TOWN OF NEWBURGH PLANNING BOARD TECHNICAL REVIEW COMMENTS

PROJECT NAME: FUCHECK SUBDIVISION

PROJECT NO.: 2021-31

REVIEW DATE: 11 APRIL 2024
MEETING DATE: 18 APRIL 2024

PRIVATE ROAD SECTION (NOT TO SCALE)

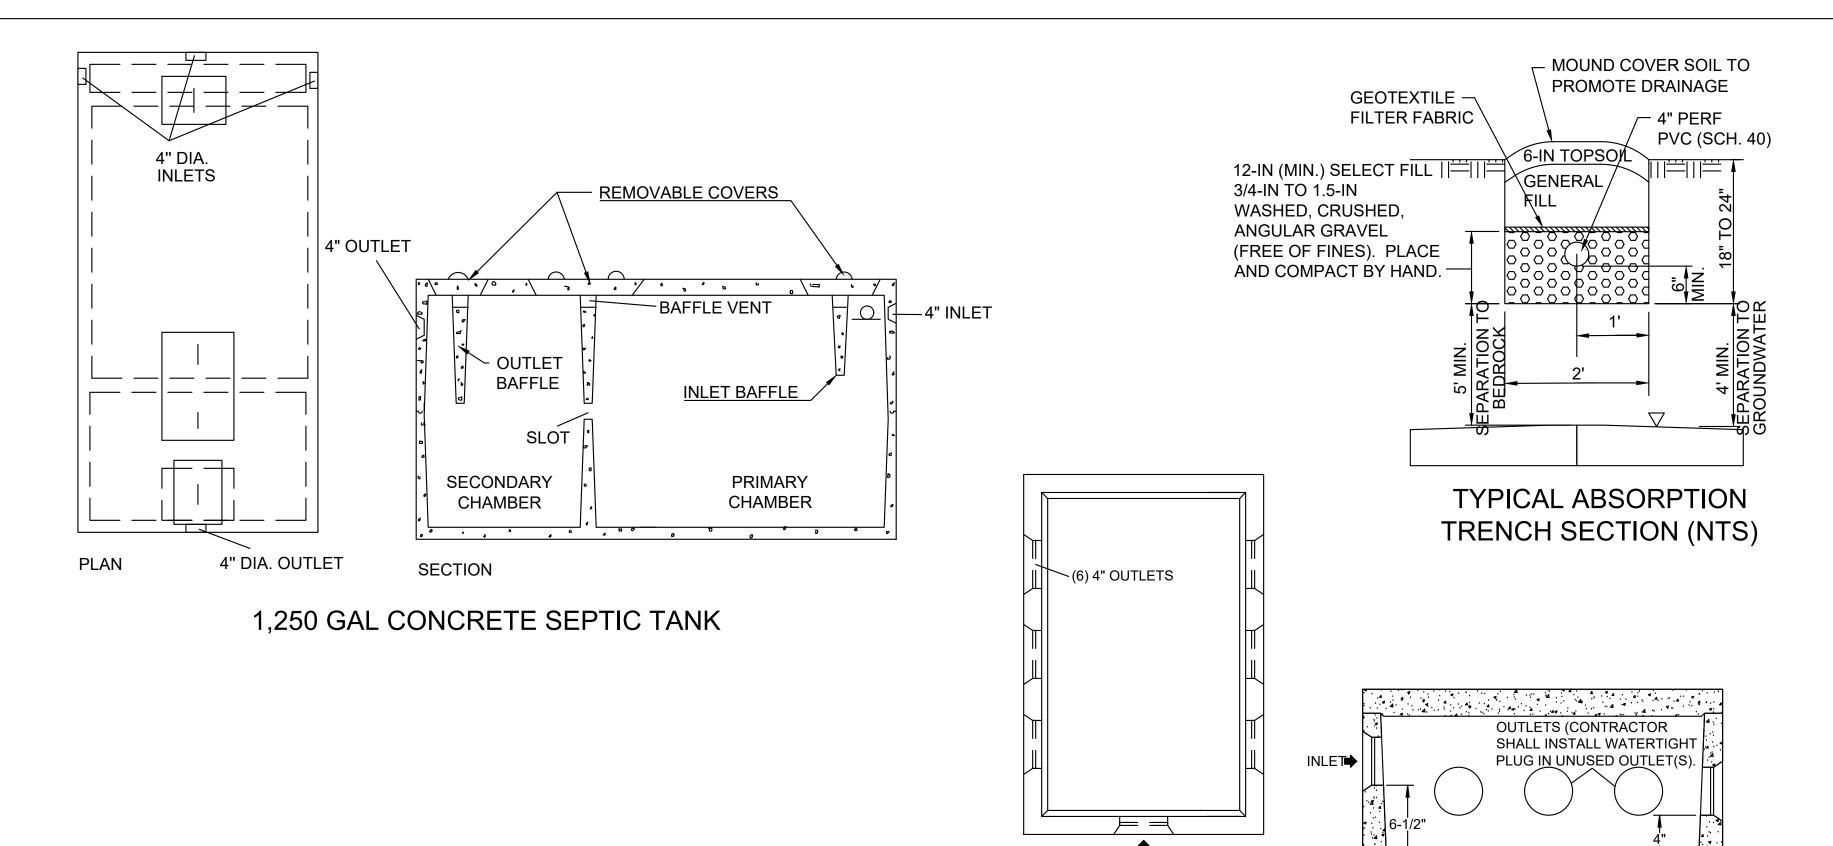
- 3. A Private Road Access Maintenance Agreement will be required.
- 4. The private road must be designed consistent with the Town of Newburgh Chapter 161- Street Specifications. Chapter 161-8 Dead Ends, requires a cul-de-sac 100 foot right of way diameter and a fifty foot diameter pavement.
